Product Change Notification

MultiTech Conduit[®] IP67 200 Series Base Station

Updated Operating System

PCN 03012022-001 (mPower – MTCDTIP2)

Upgrade Process (mPower 5.3.8)

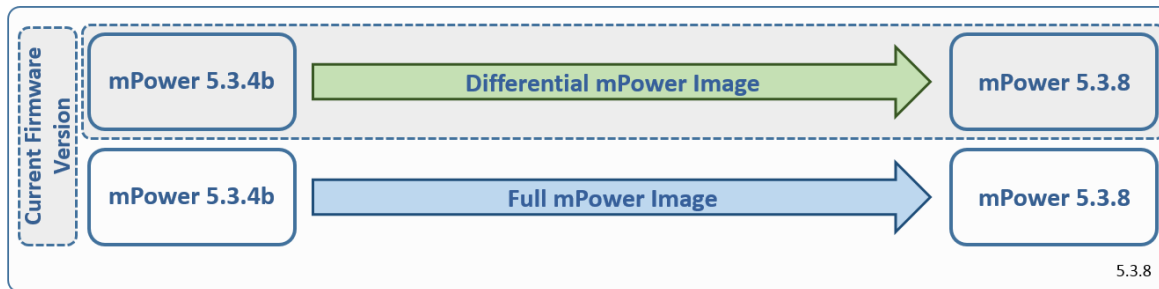
Initial MTCDTIP2- device shipments included mPower 5.3.4b. Upgrades to mPower 5.3.8 can be done in two ways:
